# NRC Staff Request for Additional Information on the Draft Basis for Section 3116 Determination and Associated Performance Assessment for the H-Area Tank Farm at the Savannah River Site

## **Executive Summary**

**Figure 1. Illustration of the as-modeled annular waste and fast pathway in Tanks 9H and 10H**

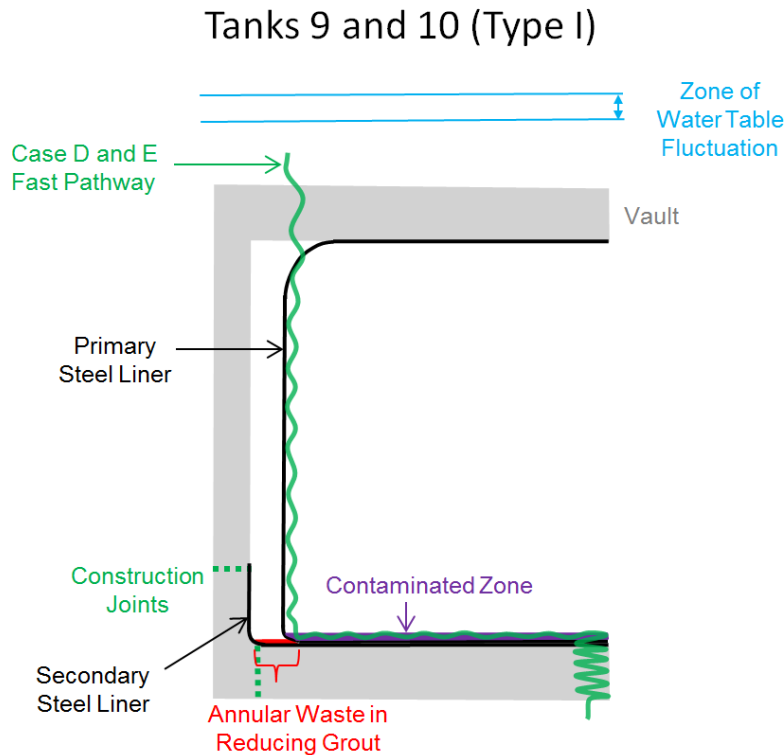
In DOE's PORFLOW<sup>®</sup> model (see Figure 1), the annular waste in Tanks 9H and 10H is loaded within the bottom of the annular reducing grout. Loading of the annular waste into the bottom of the reducing grout in DOE's PORFLOW<sup>®</sup> model assigns  $K_d$  values associated with reducing grout. For redox-sensitive radionuclides, this appears to significantly limit mobility even though this waste is assumed to be highly mobile. In addition, the preferential pathway represented in cases B-E does not intersect the annular waste in Tanks 9H and 10H. Based on operational experience, NRC staff is concerned that groundwater in-leakage into the annular region could occur and that the associated risk with this scenario is not adequately addressed within the Performance Assessment.

**Figure 2. Illustration of the as-modeled sand pad waste and fast pathway in Tanks 14H and 16H**

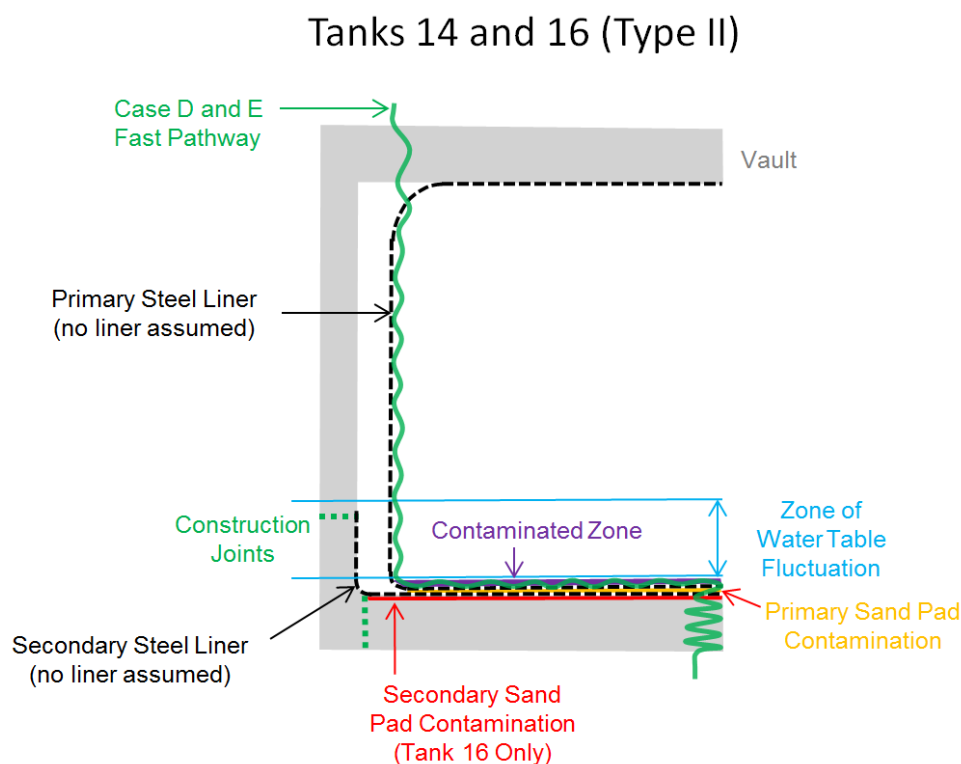
addition, the HTF Performance Assessment does not discuss the extent of diffusion out of the sand pads and into the adjacent cementitious materials.

It appears that a potentially significant fraction of the highly radioactive radionuclide inventory is diffusing into the basemat and/or contaminated zone prior to release. Diffusion of radionuclides out of the primary and secondary sand pads is facilitated in the model by a high diffusion coefficient, large concentration gradient, small diffusion length, assumption of no steel liners, and a delay in the flow through the fast pathway due to closure cap. Although the steel liners are not assumed to not be intact for Tanks 14H and 16H due to the large number of leak sites, the steel liner could still act as a partial barrier to diffusion. Also, the delay in flow through the preferential pathway, due to the assumption of flow being limited to infiltration through the closure cap, may overestimate the amount of time radionuclides can diffuse out of the sand pads if groundwater in-leakage were to occur.

short-lived radionuclides (e.g., cesium-137 and strontium-90) that decay prior to significant flow occurring in the fast flow path. DOE should also provide discussion regarding the fraction of the highly radioactive radionuclides (e.g., technetium, plutonium, and neptunium) that diffuse out of the sand pads and into the grout or basemat.
